**Customer: ENERGY INDUSTRIES OF OHIO**

**Part: SE141-114 / MODULAR COIL WINDING FORM TYPE**

Drawing ID: SE141-114                      Revision: 6  
Links: 1-Type:W: 65709/1.0 Sub: 1 Op: 50

Problem: Reference sheet 4, zone G7.

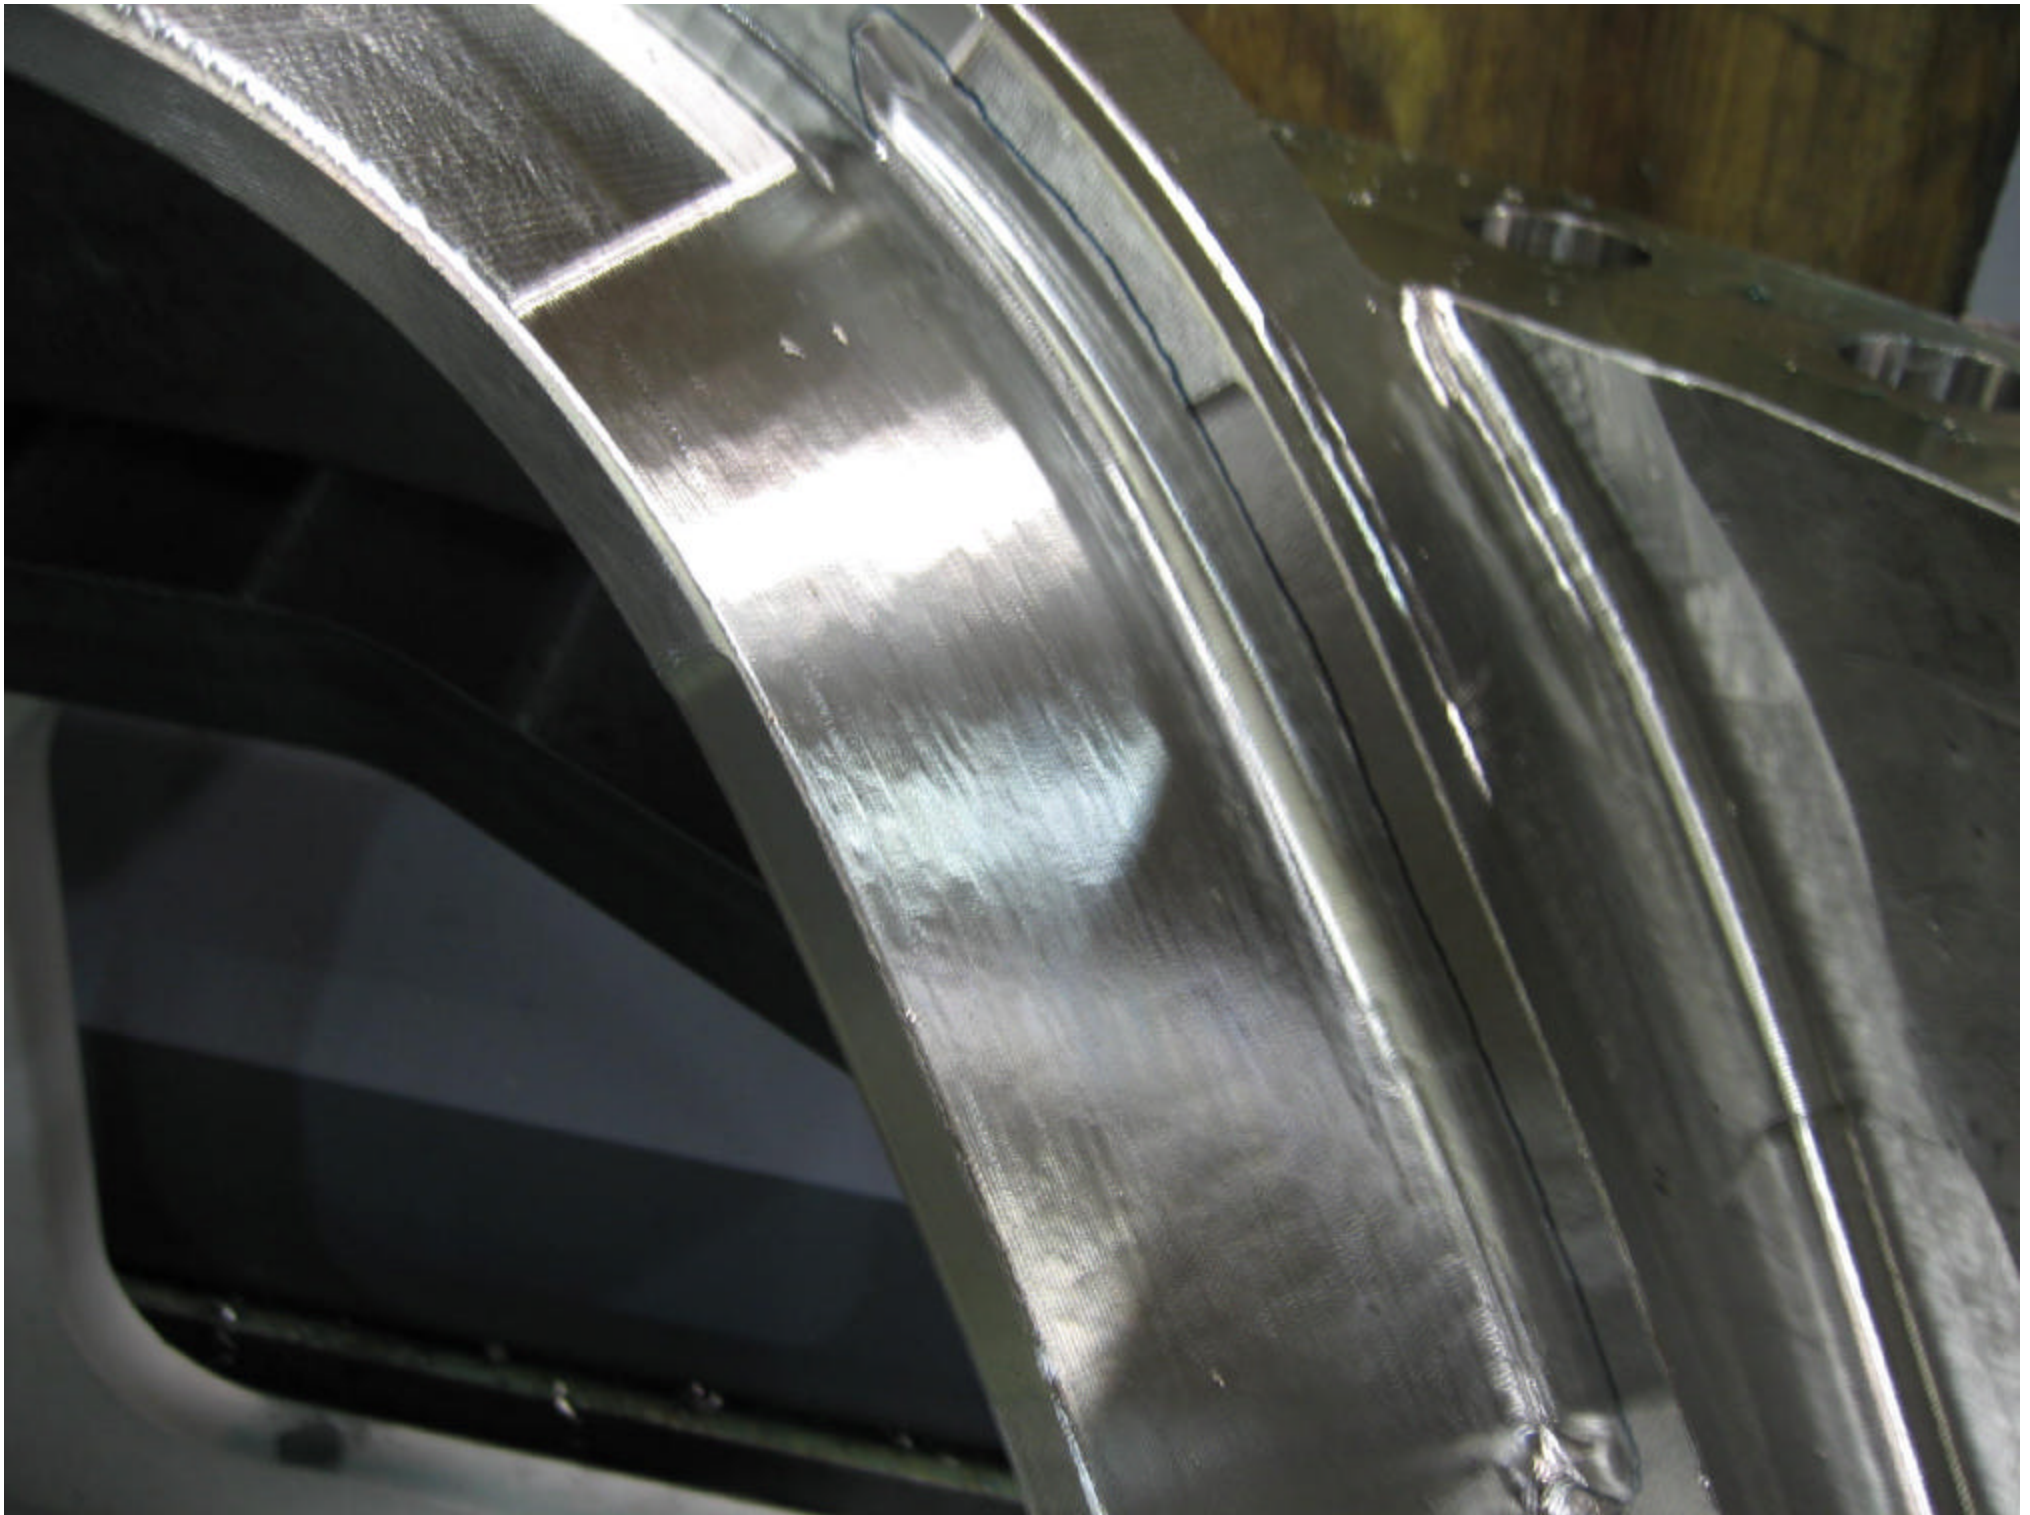
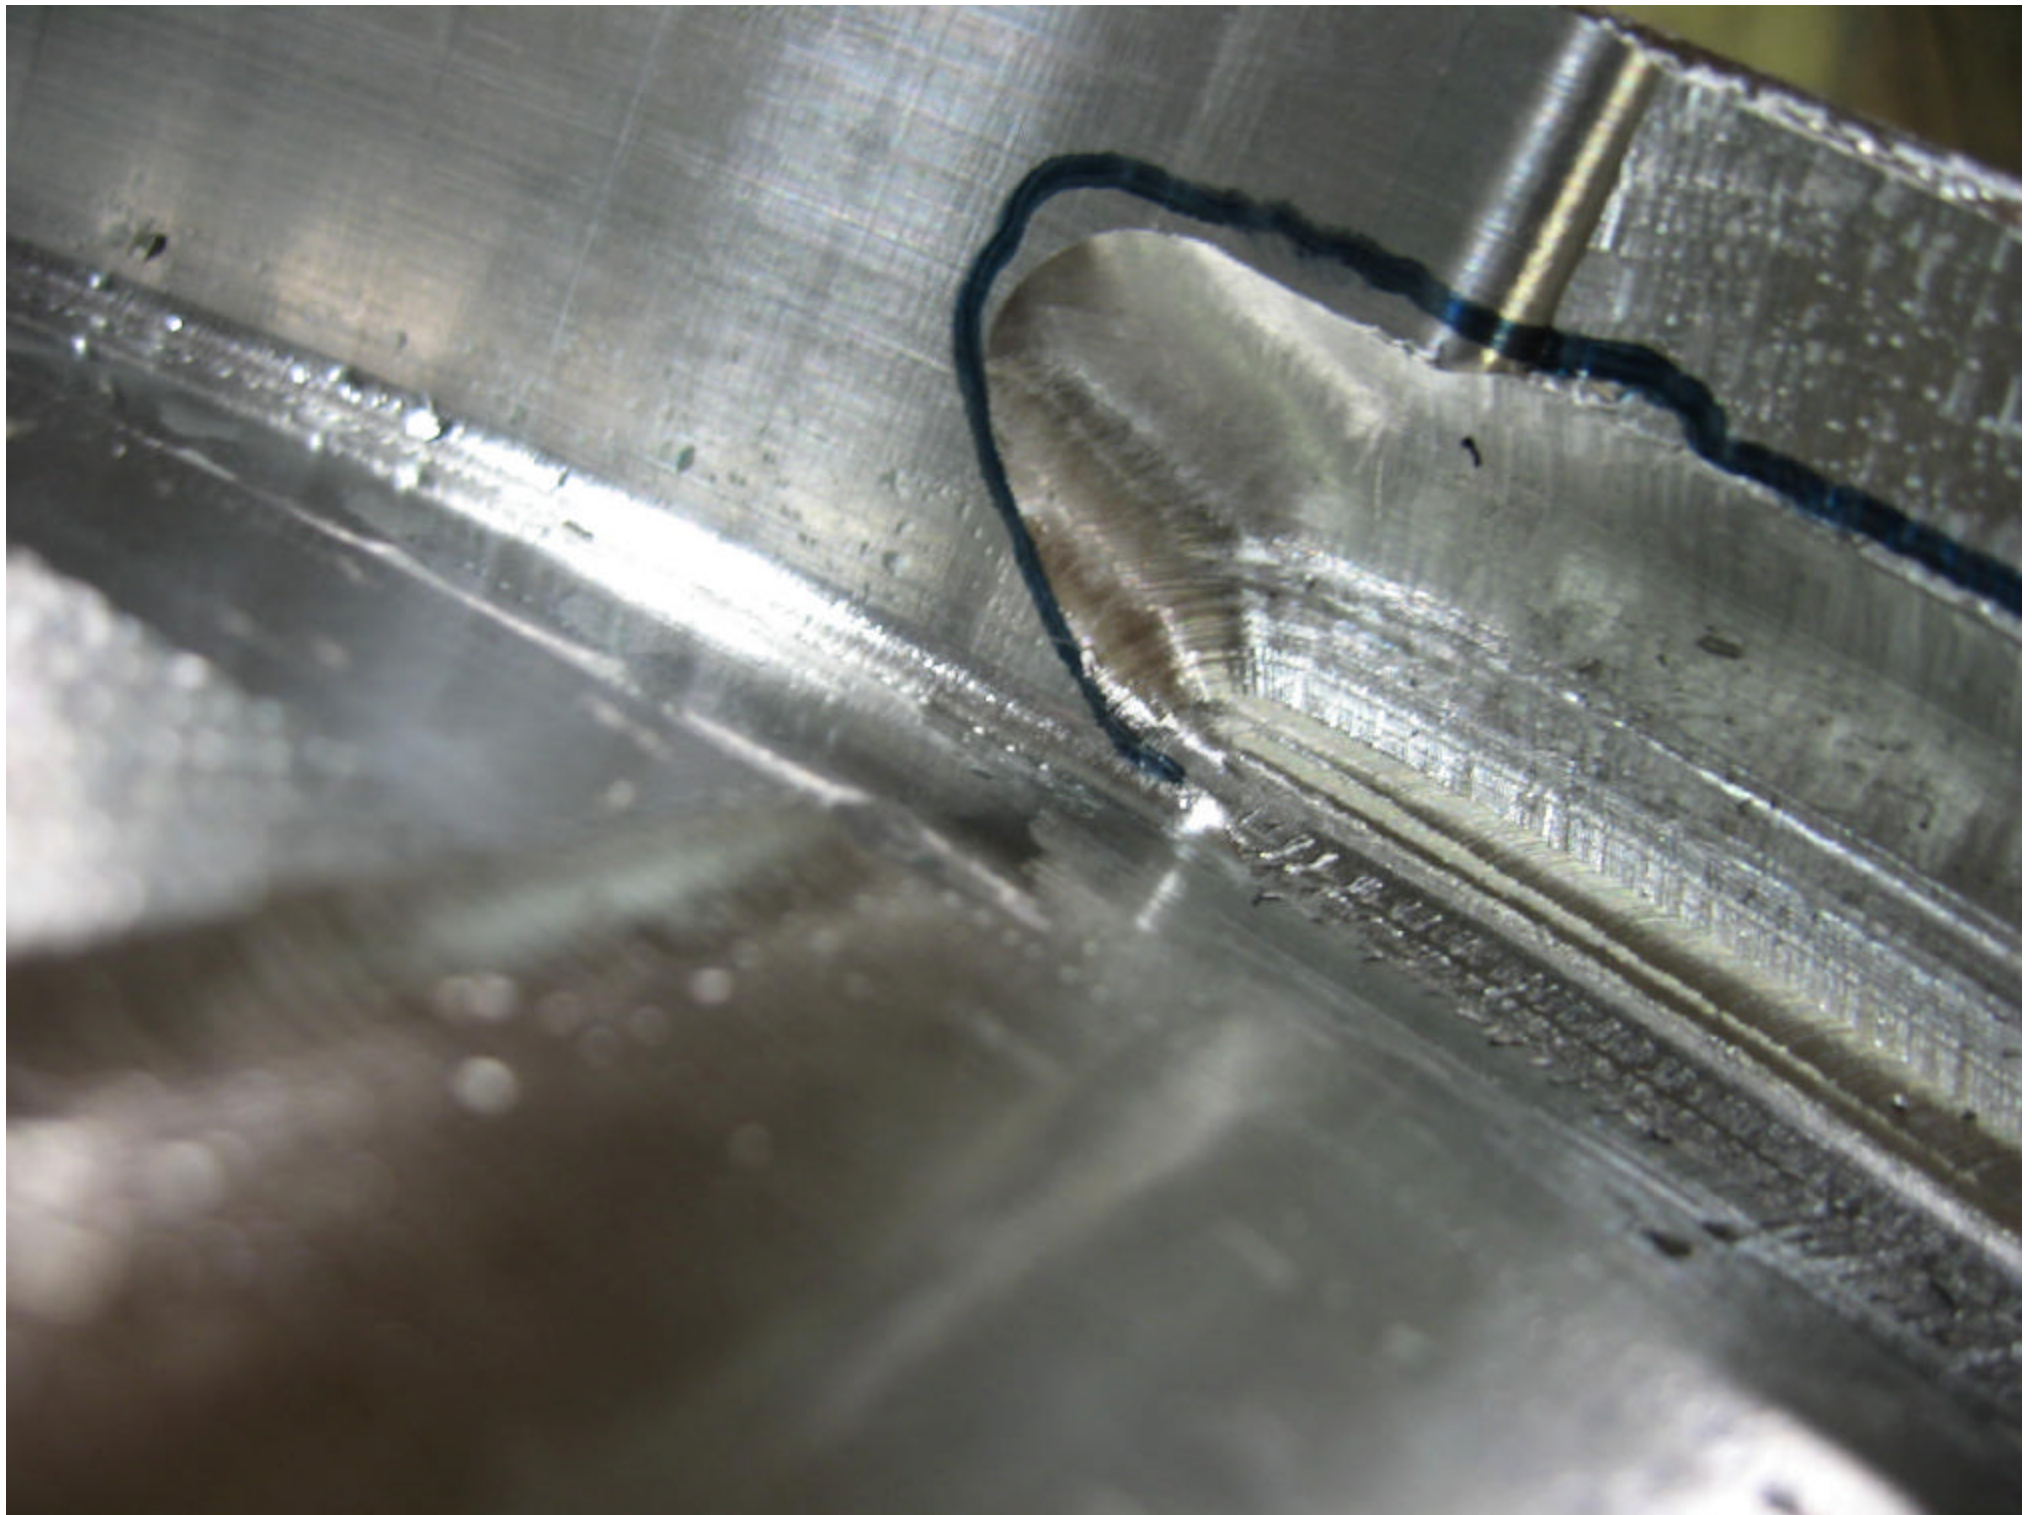
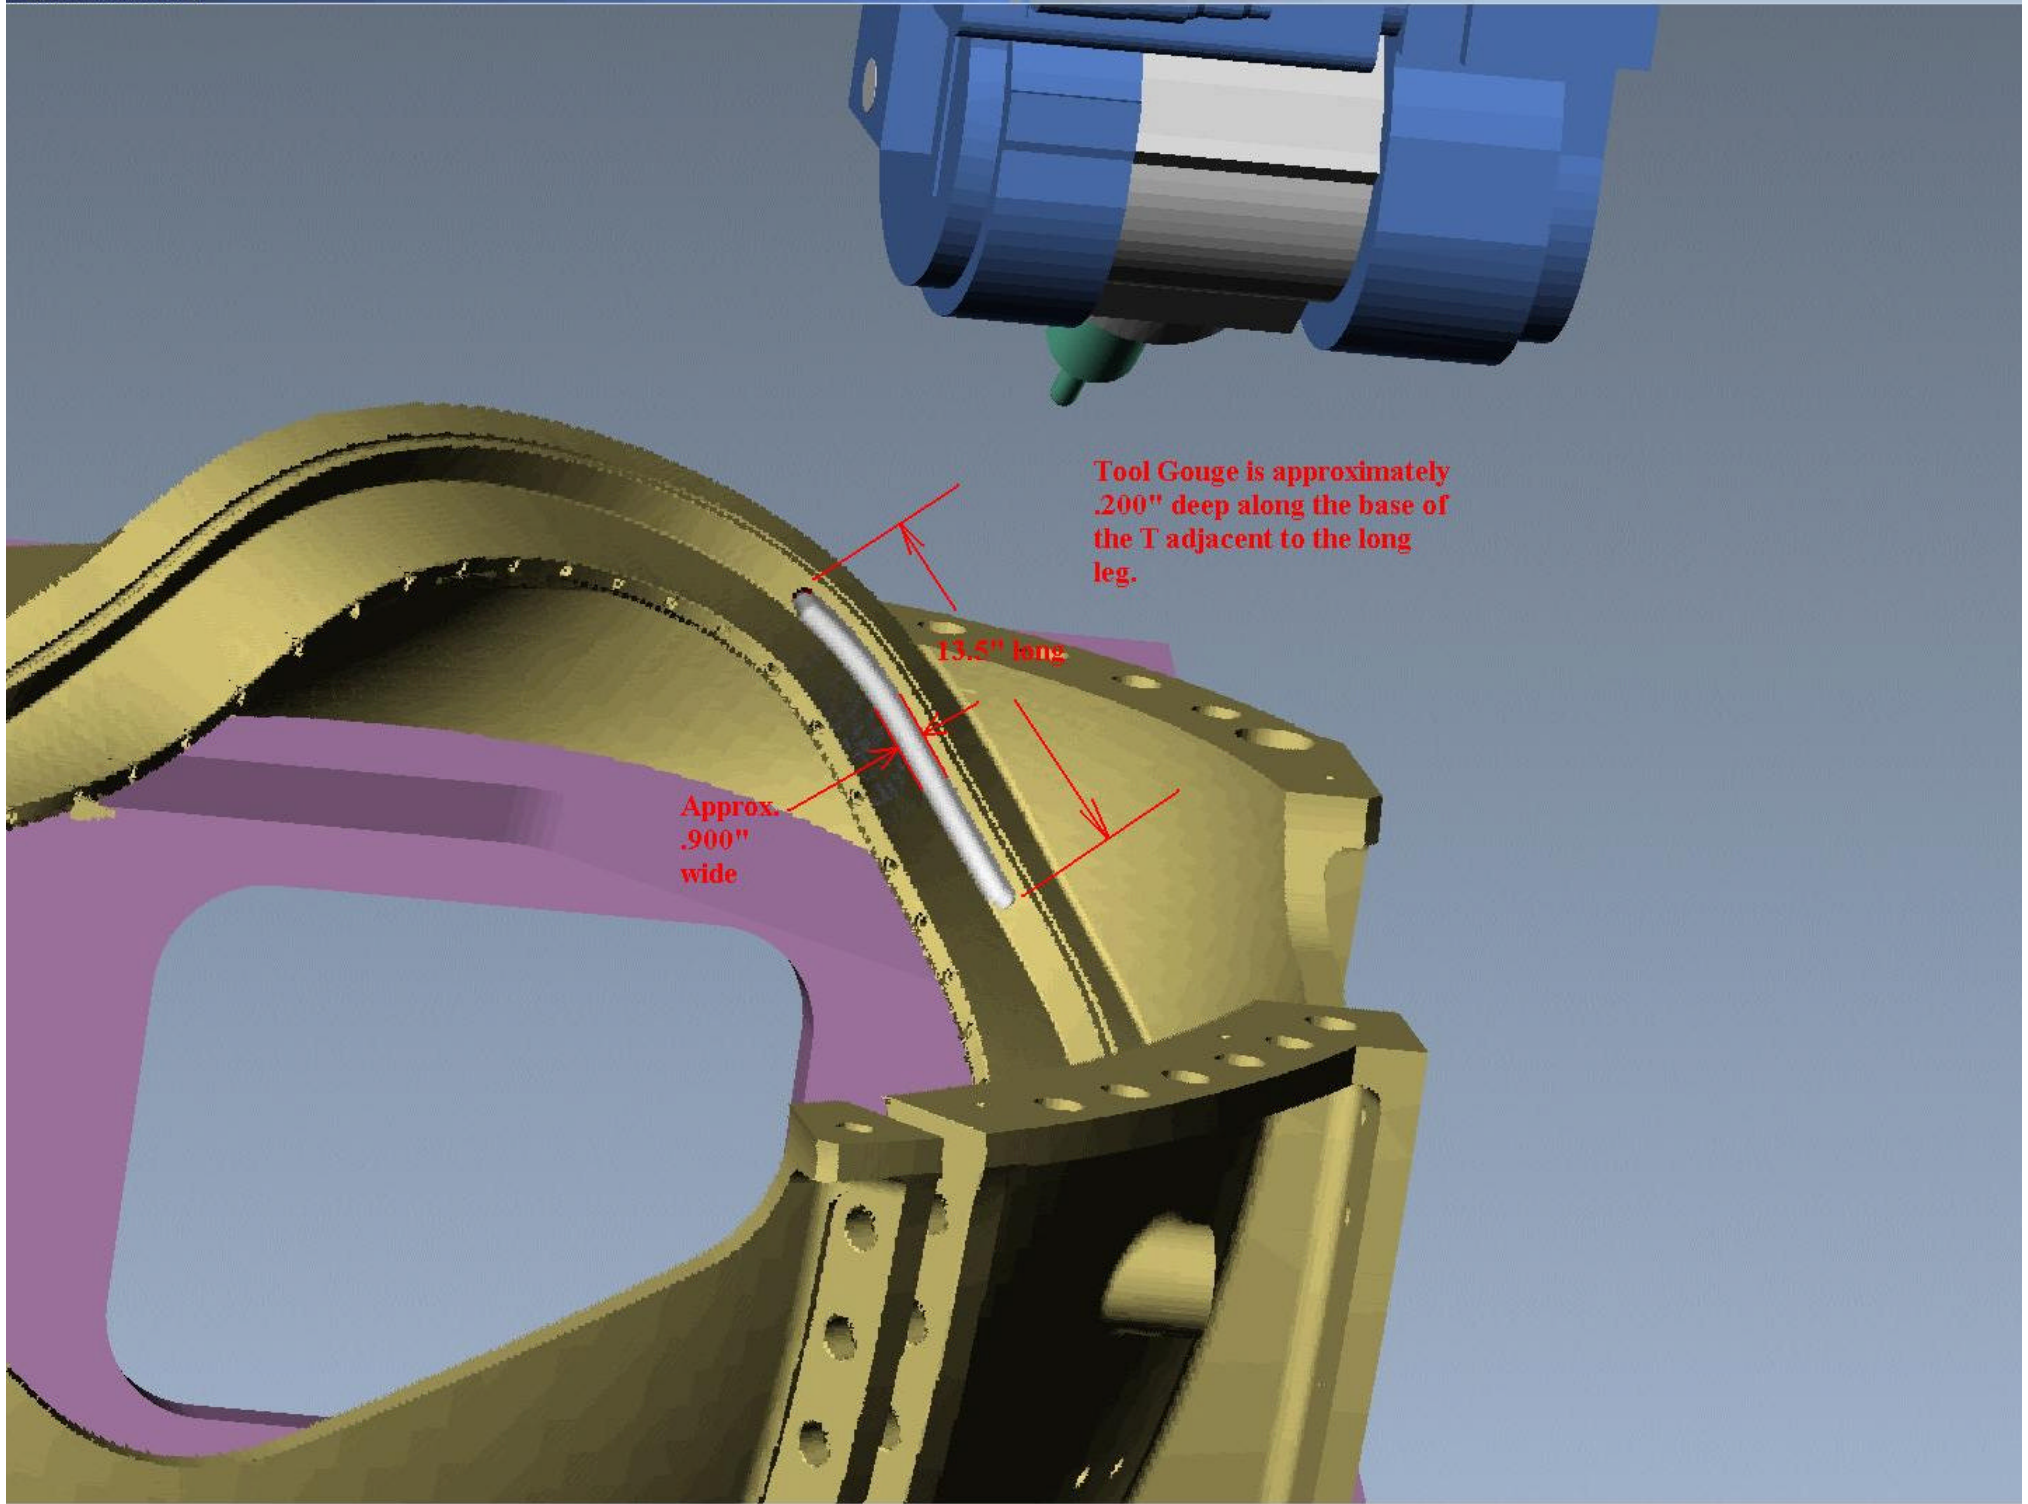
There is a tool gouge along the short leg of the T section on the Datum -D- side. The gouge is approximately 13.5" long, .900" wide and .200 deep. See attachments for clarification.

Propose to weld repair the tool gouge. Indicators would be applied on and around the T section to monitor any part movement caused by welding. The welding process would altered as needed to minimize movement. A local mag permeability and PT inspection would be performed. This gouge is located on the short leg in the area designated as "High Stress". During the RT of the High Stress area an additional shot would be taken of the repaired area. It is likely that this RT shot would prove inconclusive due to it's location.

- 1) The tool gouged the wall because the toolpath was generated incorrectly. The check surface (back wall) was not selected and therefore the toolpath gouged the back wall.
- 2) The toolpath (n/c program 31501) was released as a good program because the verification did not show / flag an error of the toolpath violating the design model.

Tool Gouge is approximately  
.200" deep along the base of  
the T adjacent to the long  
leg.

13.5" long

Approx.  
.900"  
wide

NCSX agrees with MTM's recommended disposition to weld repair, followed by local mag. perm. Inspection, PT inspection, and RT during the RT of the high stress area. MTM is requested to provide documentation after the repair is completed.
